Aft mainsheet bridle attachment experiment

Suggested installation instructions

September 25, 2018

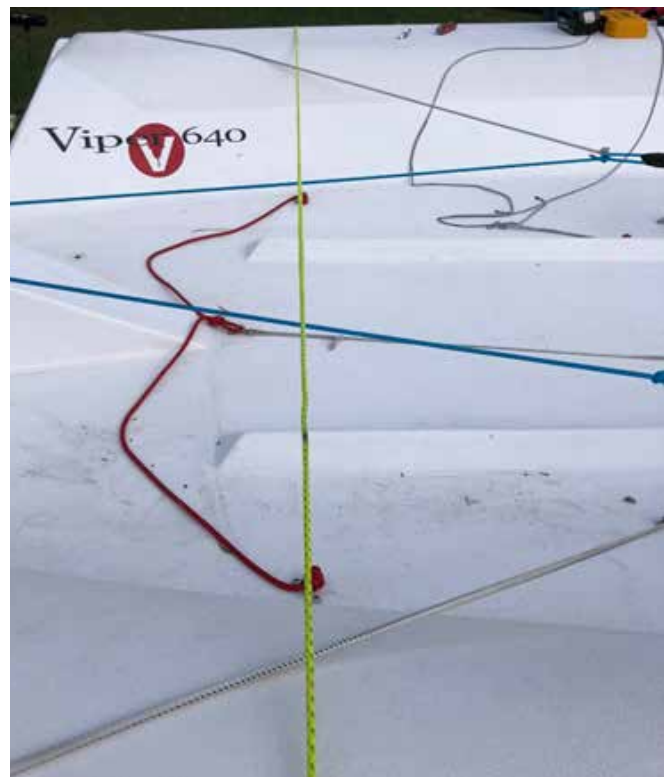
Rule 6.3.2 currently includes the sentence; “The bridle must be attached to the two mid bridle or aft bridle pad eyes installed by the builder.” During this testing period, an aft bridle (if used) may be attached to each gunwale at points directly across the cockpit and in line with the aft bridle pad eyes (within +/- 5mm fore-aft). Holes may only be drilled in the outer angled gunwale face, and no additional hardware or fittings may be added to the boat. Photos show a test setup. Bridle lines are not specified in our rules, but low stretch 12-strand Dyneema is a good choice.

This configuration is allowed for all boats through the later of June 30, 2019 or the start of the next North American or World championship.

Please note that only holes can be drilled in the angled gunwale surface and no additional hardware can be attached like eye straps. The test only applies to the aft bridle and block if used and does not apply to the aft split tail. Installation is relatively easy and should take about 10 to 15 minutes.

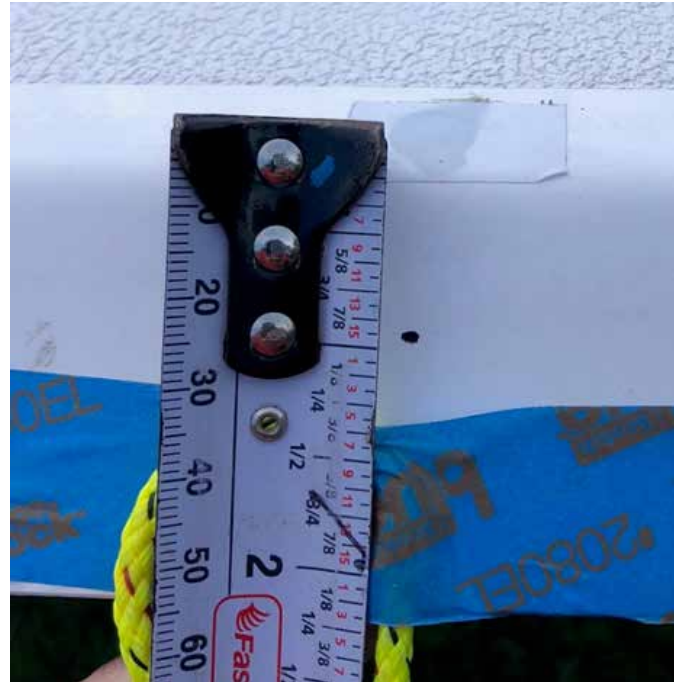
Step 1. Locate points on the gunwale in line with the center of the aft mainsheet eye straps on the cockpit floor.

A thin line can be taped to the gunwale sides and moved until when looking straight down on the line, it visually lines-up with the two eye straps.

This seems more accurate than a measurement from the stern quarters as they have been repaired on many boats and there is not a consistent measurement point there.
